SECTION 00 91 11 - ADDENDUM NUMBER 2

Date: February 7th, 2025
Project: NGFD English Road Station - Contracts DEFG
Project Number: 20233530.0001

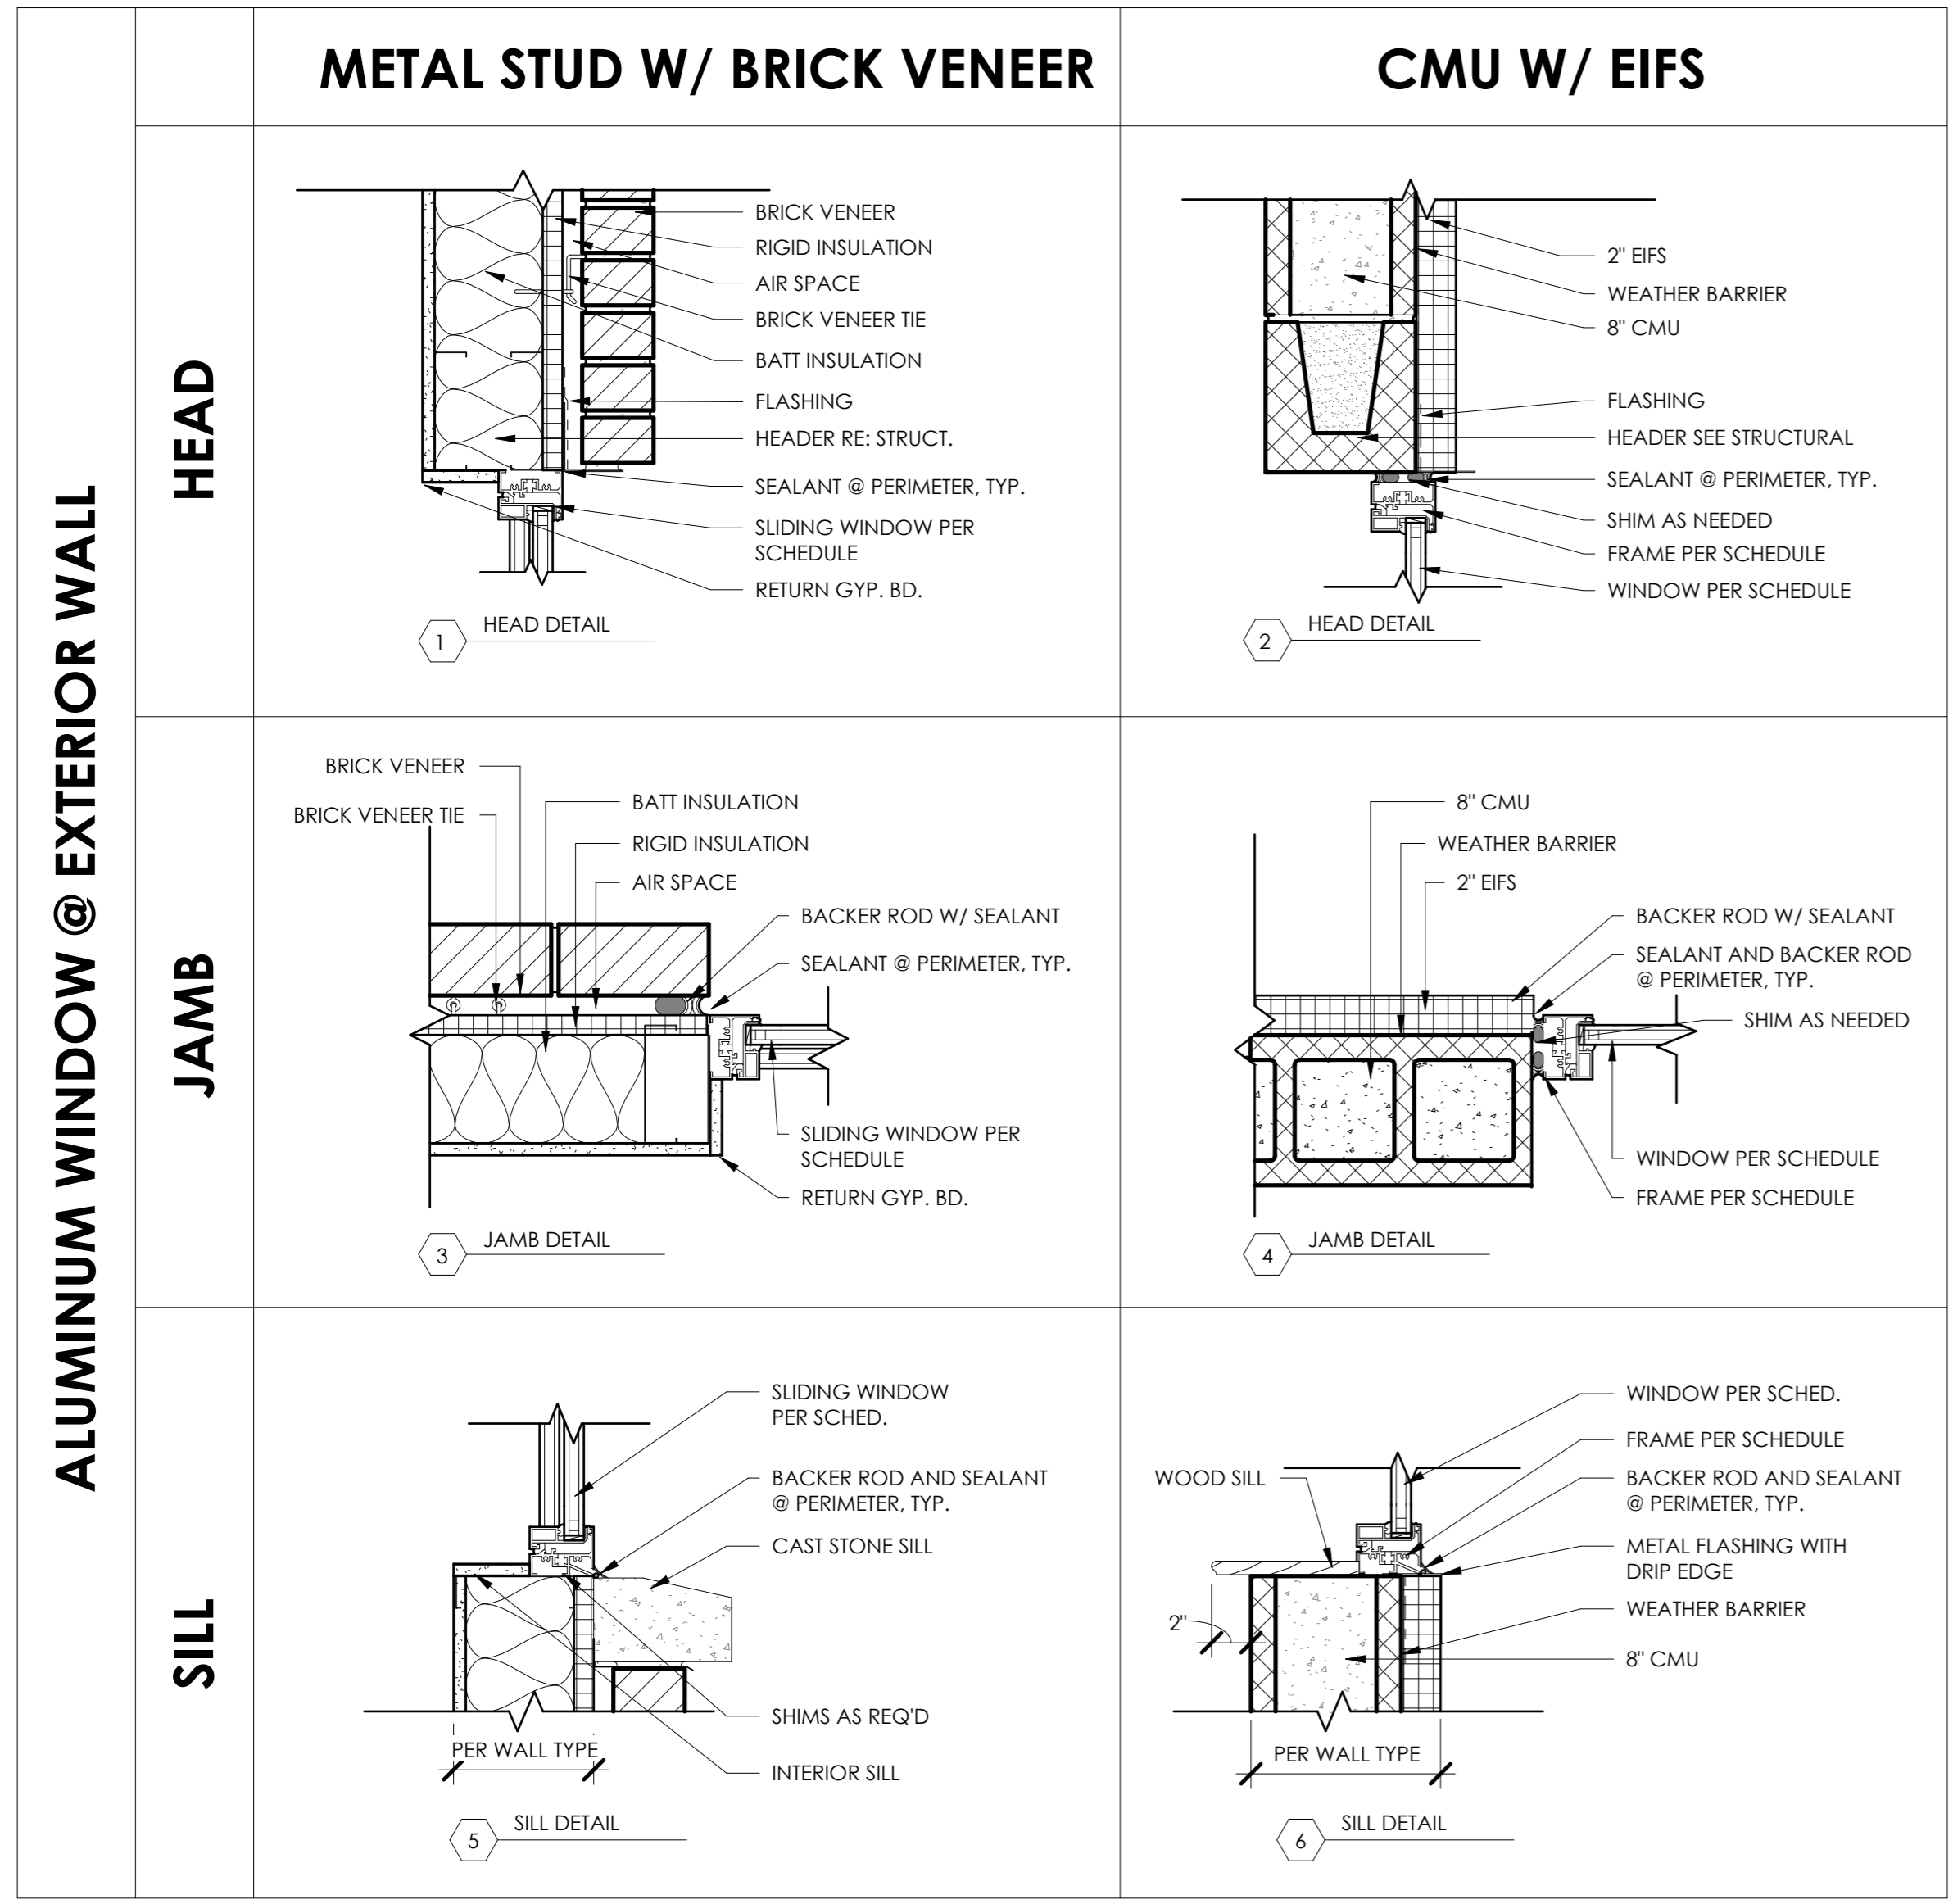
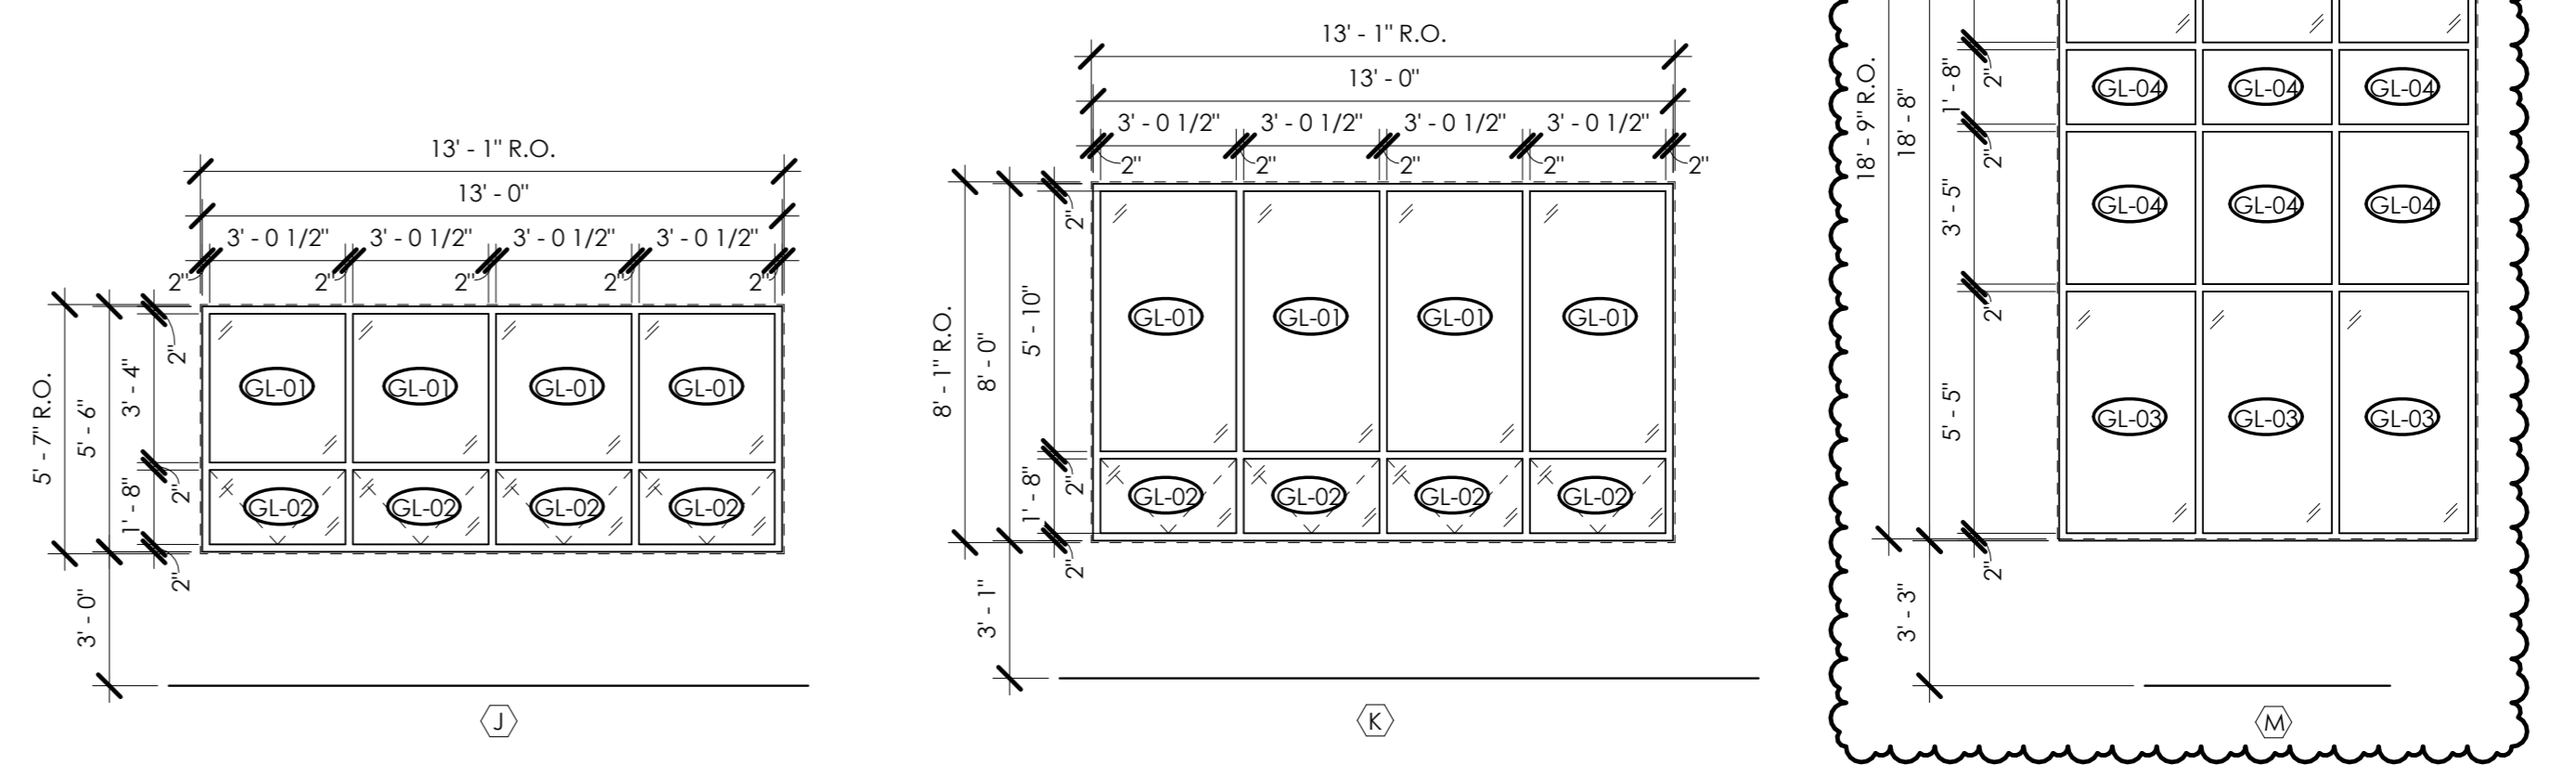
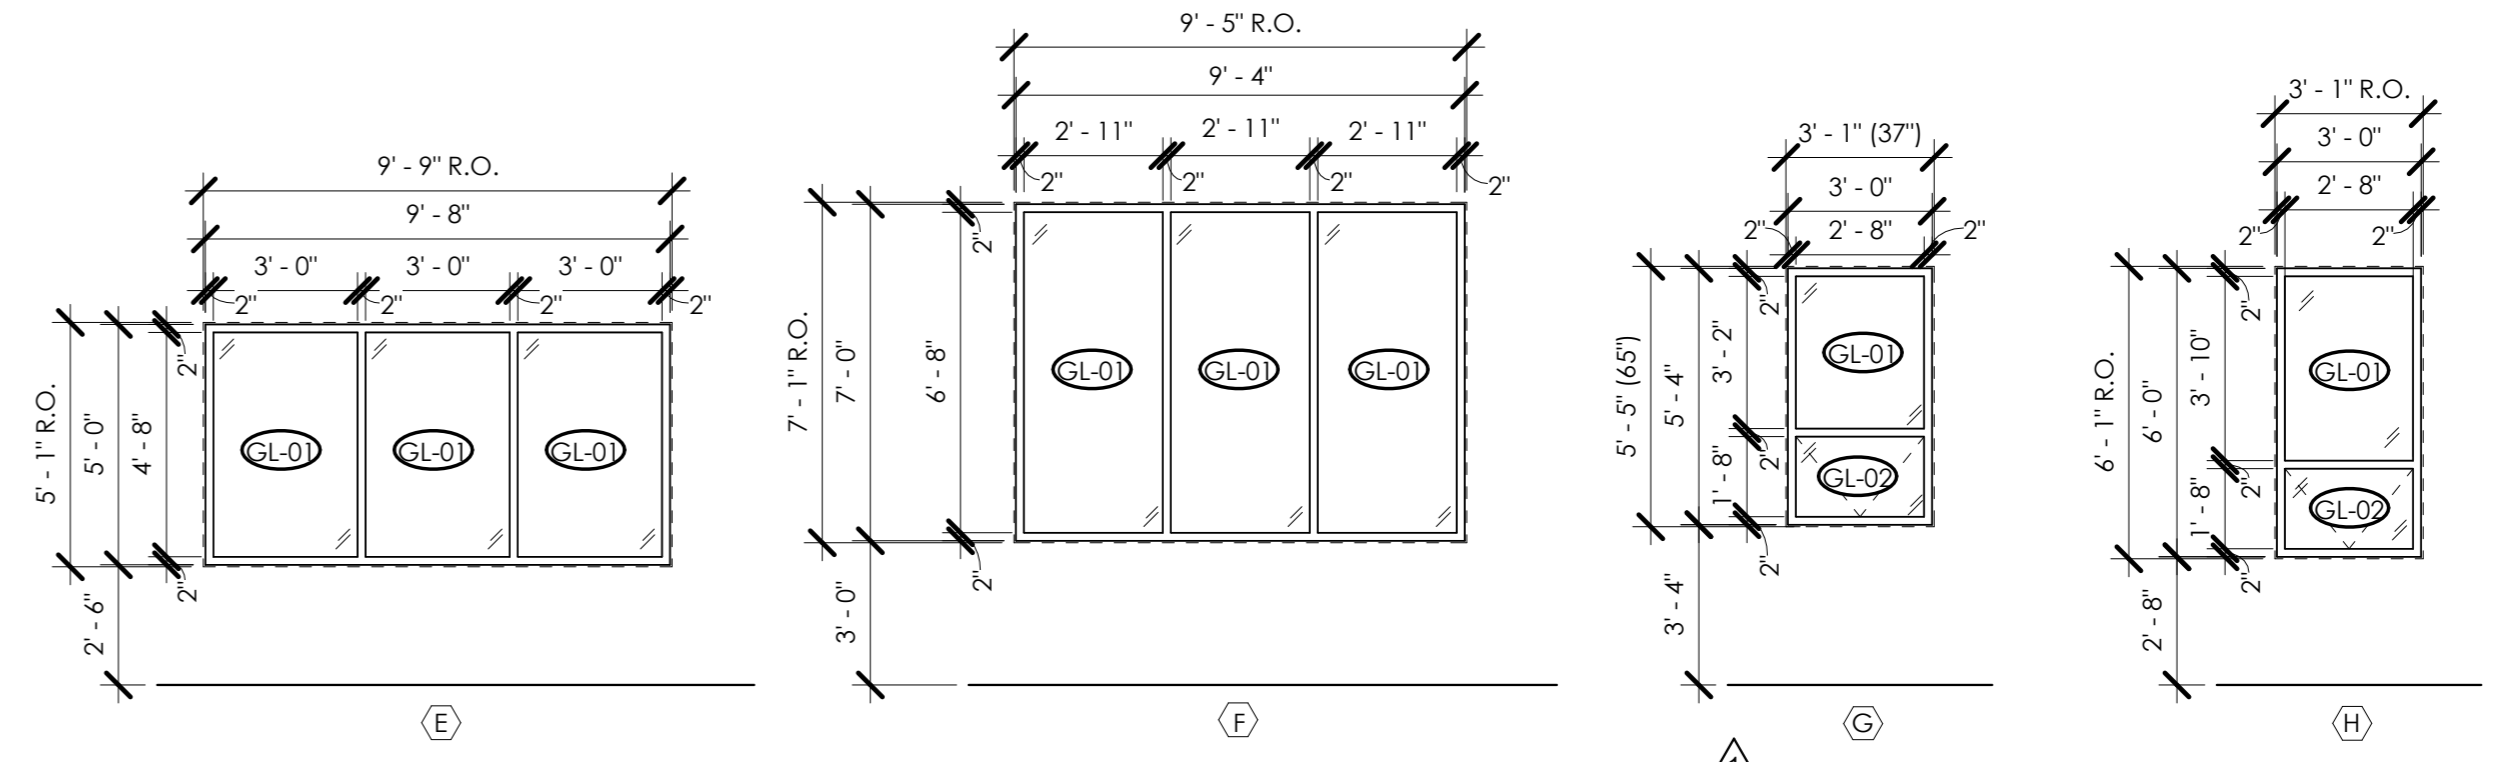
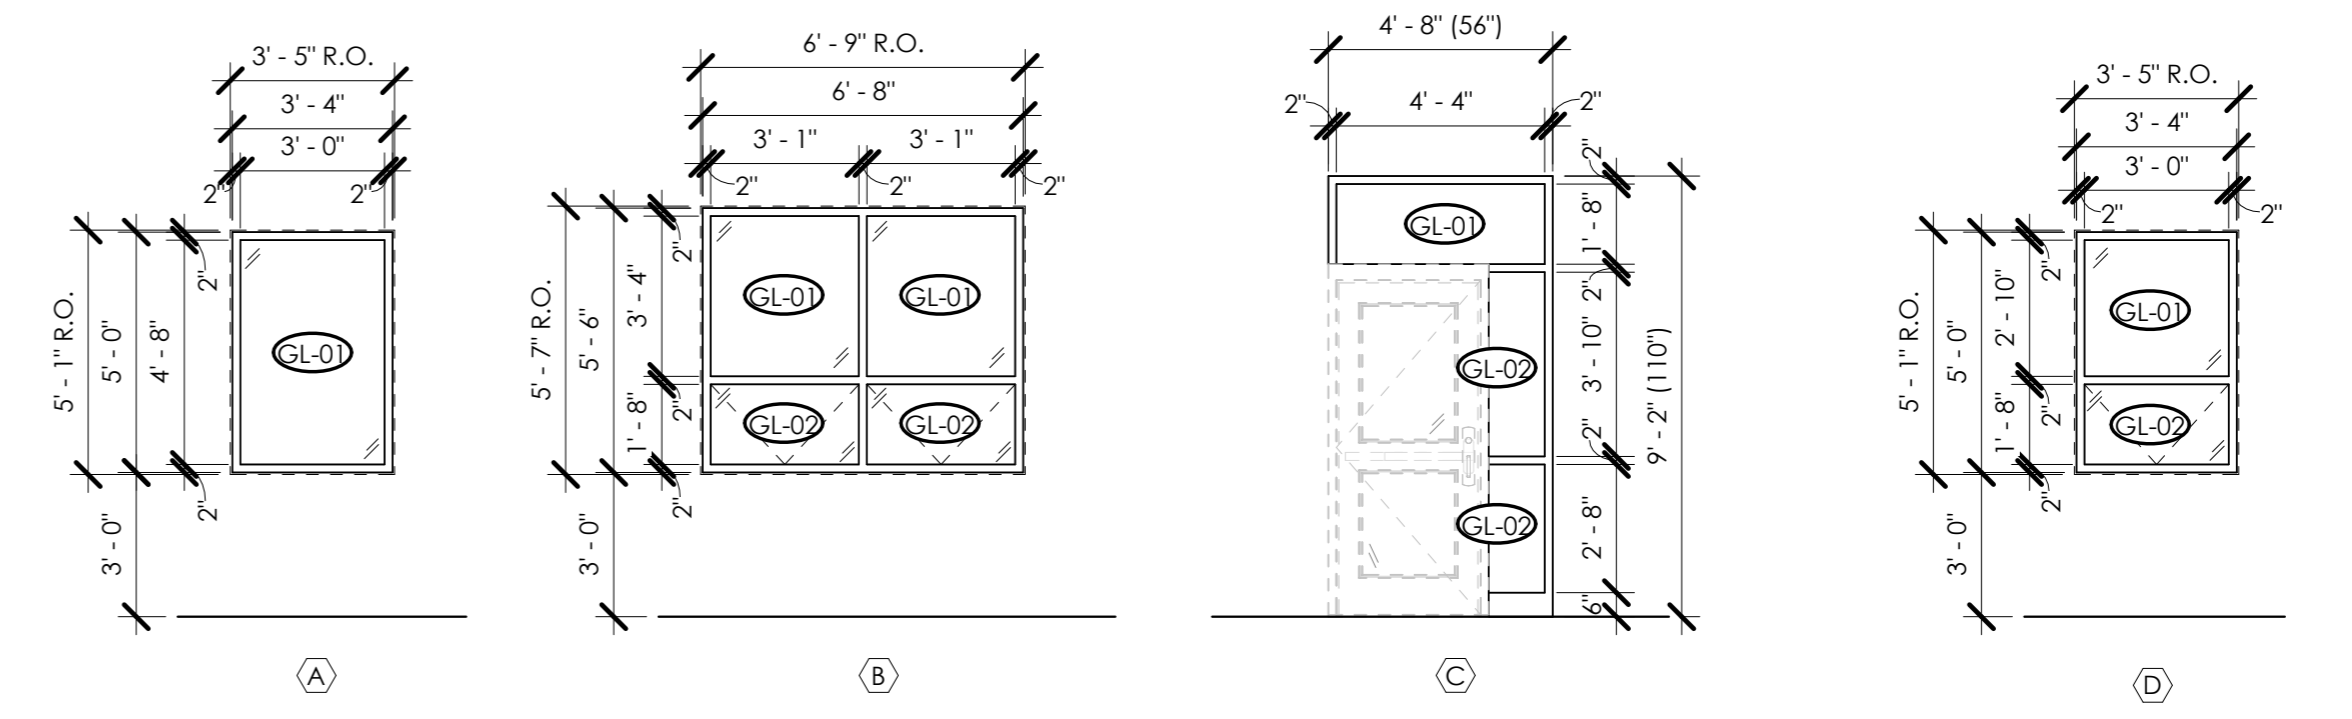
1. A-100 First Floor Plan
 - AV Room Number and Door Number to 104A.
2. A-103 Roof Plan
 - Downspouts added and called out.
3. A-200 Exterior Elevations
 - Downspouts added and called out.
4. A-201 Exterior Elevations
 - Downspouts added and called out.
5. A-318 Wall Section Details
 - Detail 1 revised to reflect correct rainscreen installation requirements.
6. A-400 Enlarged Plans & Interior Elevations
 - Dimensions adjusted along west wall of Workshop.
7. A-407 Enlarged Plans & Interior Elevations
 - Door tag changed to 104A.
8. A-501 Roof Details
 - Box gutter detail dimensions revised.
9. A-600 Door Schedule
 - Door schedule updated.
 - Door frames updated.
 - Glazing types added.
10. A-601 Door Details
 - Door Head and Door Jamb Metal Stud with EIFS added.
11. A-602 Window Schedule
 - Glazing types added for window M.
